SUNSET HILLS SUBDIVISION, BLOCK E, RESUBDIVISION OF LOT 2

APPLICATION NUMBER 17 DATE December 6, 2007

REQUEST Subdivision

SITE PLAN

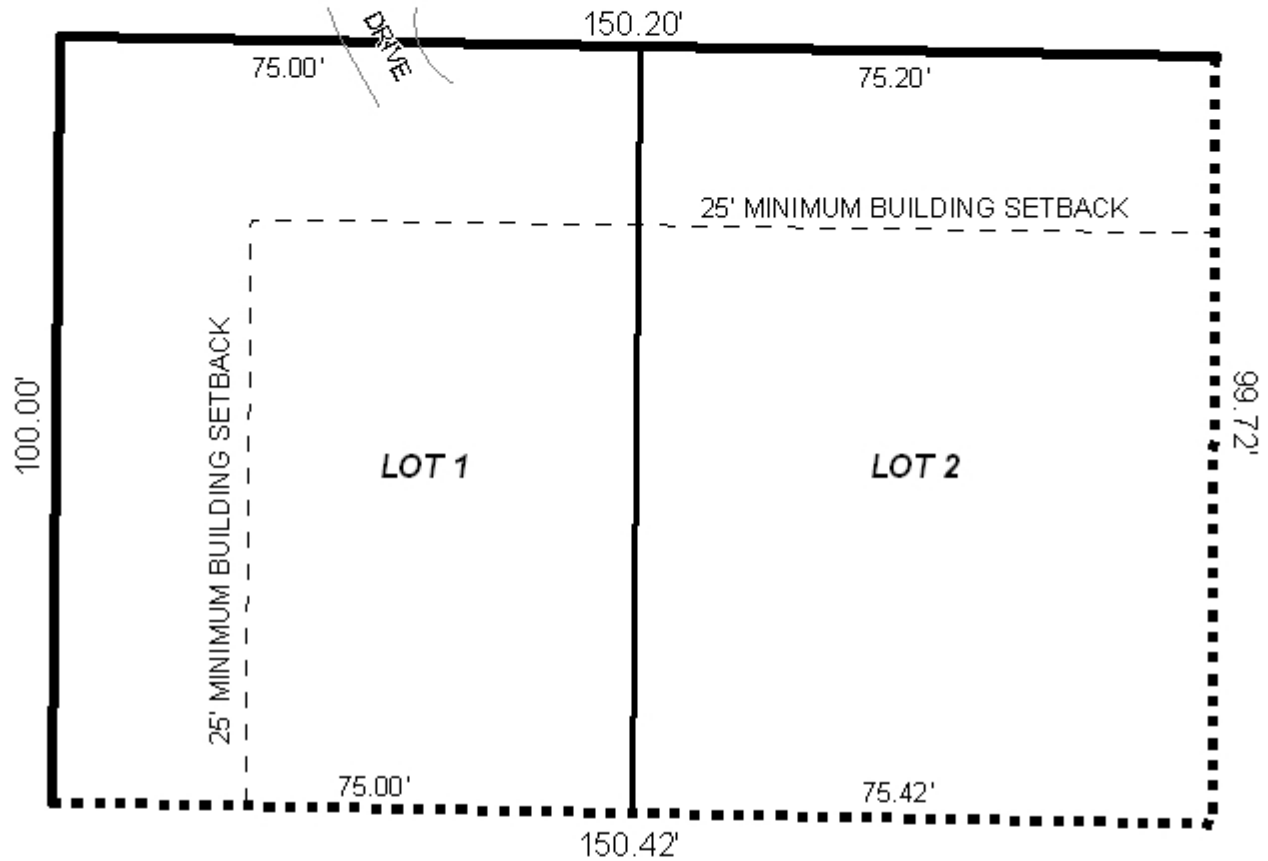
The site fronts University Boulevard Service Road and Sunset Drive South. Right-of-way widths are consistent with Section V. of the Subdivision Regulations. However, there is no corner radius provided; therefore, dedication to provide a 25' radius at the corner of University Boulevard Service Road and Sunset Drive South should be required. The plat illustrates the required 25' minimum building setback line along both street frontages, and this should also be depicted on the final plat.

Lots are labeled on the plat and should also be labeled on the final plat, or a table provided furnishing the same information.

Each lot should be limited to one curb cut, with the size, design, and location to be approved by Traffic Engineering and conform to AASHTO standards, and a note should be placed on the final plat stating such.

1. dedication to provide a 25' radius at the corner of University Boulevard Service Road and Sunset Drive South;
2. depiction of the 25' minimum building setback line along both street frontages on the final plat;

3. labeling of each lot with its size in square feet, or provision of a table on the plat depicting the same information;
4. placement of a note on the final plat stating that each lot is limited to one curb cut, with the size, design, and location to be approved by Traffic Engineering and conform to AASHTO standards; and
